Generic Environmental Impact Statement for License Renewal of Nuclear Plants

Supplement 22

Regarding
Millstone Power Station, Units 2 and 3

Final Report

Figure 2-6. Comparison of Winter Flounder Population Trends in the Niantic River and the Region

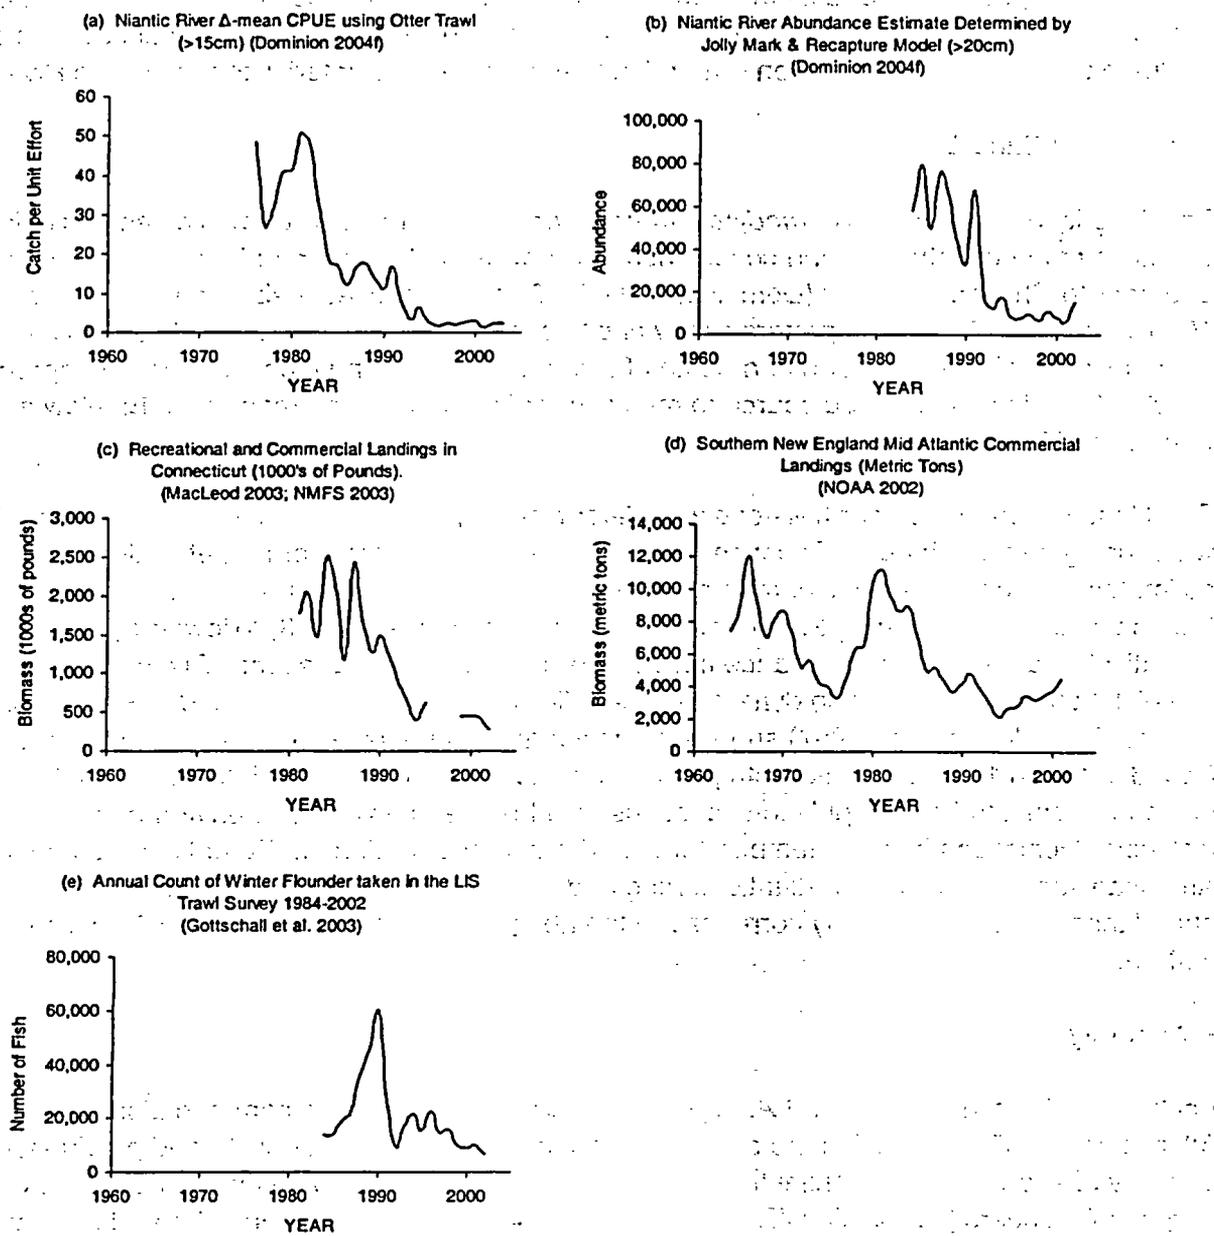
Comment: Section 2.2.5.5 Population Trends Associated with Important Fish and Shellfish Species Page 2-25, Line 36 and Page 2-26, Figure 2-6. Draft GEIS Supplement 22 Statement - ...reporting years (Figure 2-6) (NOAA 1998; MacLeod 2003; National Marine Fisheries Service... Dominion Comment - It is suggested that "Gottschall et al. 2003" be added to the reference list for Figure 2-6 online 36, and in the figure itself. Gotschall et al. is the citation for the CTDEP Long Island Sound Trawl Survey. (MPS-47-21)

Comment: The Coalition has reference to Figure 2-6 ("Comparison of Winter Flounder Population Trends in Niantic River and Long Island Sound"). This figure illustrates clearly that while the winter flounder fishing stocks in the region are rebounding – perhaps due in part to fishing restrictions that apply throughout the region – the Niantic River winter flounder population continues its collapse.

It is submitted that if the SEIS staff had pondered the ramifications of Figure 2-6 in consultation with the Niantic fishermen who have gone out of business and the fishermen's expert witnesses and CTDEP's marine biologist Victor Crecco, in light of all the facts and circumstances, the NRC staff would have been compelled to categorize the impact to Niantic winter flounder from continued operations of Millstone in a license renewal period to be "major" and devastating and probably irreversible.

Response: *Figure 2-6 has been revised to clarify local and regional population trends for winter flounder. Based on review of the data, the staff agrees with NOAA Fisheries that the resource continues to be overfished and that the stock throughout the region is depressed, including the Niantic River population segment. It is unlikely that Millstone is depressing the population segment in the entire Long Island Sound region, or that the Niantic River population segment is not receiving the same fishing pressure that the rest of the Long Island Sound population segment is experiencing, since winter flounder from the Niantic River range throughout southern New England. To further support this thesis, extended shutdowns of Millstone, Units 2 and 3 from 1997 to 1999 did not result in marked increases in year-classes or adult recruitment of winter flounder from the Niantic River.*

Response: *The comment states that the "operations of Millstone Nuclear Power Station have driven the winter flounder to virtual extinction." The NRC staff does not agree with the statement. NOAA Fisheries classifies the Southern New England/Mid Atlantic (SNEMA) winter flounder stock complex as overfished, not near extinction. Winter flounder population trends depicted in Figure 2-6 show an overall decline in Niantic River abundance, and also an overall decline in winter flounder in Long Island Sound.*
